2nd November 2015

Macken Strategic Planning has been engaged by The Infants' Home (TIH) on cnr Frederick and Henry Street, Ashfield to review the EIS for M4 East Extension and prepare a submission on their behalf outlining their concerns and issue with the proposal. TIH is a charitable organisation which integrates early childhood education, early intervention and specialist health services for young children in the Sydney area. TIH currently provides these services to over 2,200 children and families, especially to those living in vulnerable circumstances, from across the greater metropolitan area. TIH is one off Sydney's oldest charities and has been delivering services to children and their families from this site for 140 years.

The proposed Tunnel alignment:

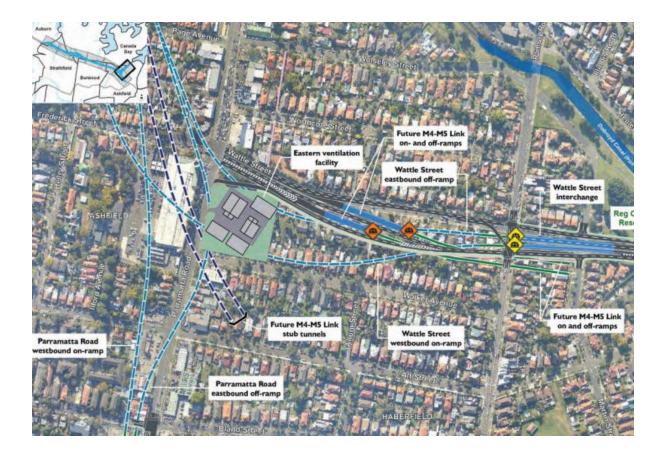
The rationale behind the preferred route being chosen is both understandable and supported. This route will allow for a shorter tunnel and allow for more medium density housing along Parramatta Road. However the preferred route for the tunnel comes very close to TIH property, travelling just a few metres from the north western boundary and under the adjacent Bunnings building. We believe that during construction, vibration and subsidence could have a significant impact on some The Infants' Home buildings, many of which are heritage listed. TIH site, some of its building and all its landscape are heritage listed. We request that the proponent be required to undertake a full

dilapidation report and a heritage assessment of all The Infants' Home buildings and structures prior to construction starting and that the proponent be required to make good any damage arising from this construction.

TIH is also concerned that having the Tunnel so close to their property may sterilise the future redevelopment and expansion of services. The Infants' Home currently has an approved DA for a large car park which is essential for the service expansion to meet the identified needs. The Infants' Home is concerned that having the tunnel so close to the centre, and at a depth of only 30 metres, may lead to restrictions being placed on future excavation of the property. The Infants' Home has also recently been zoned for residential development. While the Infants' Home has no immediate plans to develop in accord with this zoning, it does represent a significant uplift in the value of the property. We are seeking assurances that the development of the M4 East tunnel will not in any way prevent the orderly development of the facility at Frederick Street. Furthermore, should the tunnel place any undue development restrictions on The Infants' Home properties they have a reasonable expectation of compensation.

The Infants' Home accepts the rationale behind the decision to have the tunnel run to the south of Parramatta Road to allow for the redevelopment of properties along the road. However the draft **Parramatta Road Urban Transformation Strategy** indicates that the section of Parramatta Road near the Frederick and Wattle Streets is unsuitable for redevelopment. Therefore we believe that there is a strong case to amend the proposed route for the tunnel to bring it back under Parramatta Road alignment further to the west of Frederick and Wattle Streets. This would reduce the number of properties affected by construction without sterilising any future redevelopment opportunities.

Many of the concerns The Infants' Home has in relation to the proposed tunnel alignment can be addressed by reconsidering the alignment of the Parramatta Road and Wattle Streets, westbound on-ramps. Moving both of these on-ramps slightly to the north and west would significantly reduce the tunnels impacts on The Infants' Home.
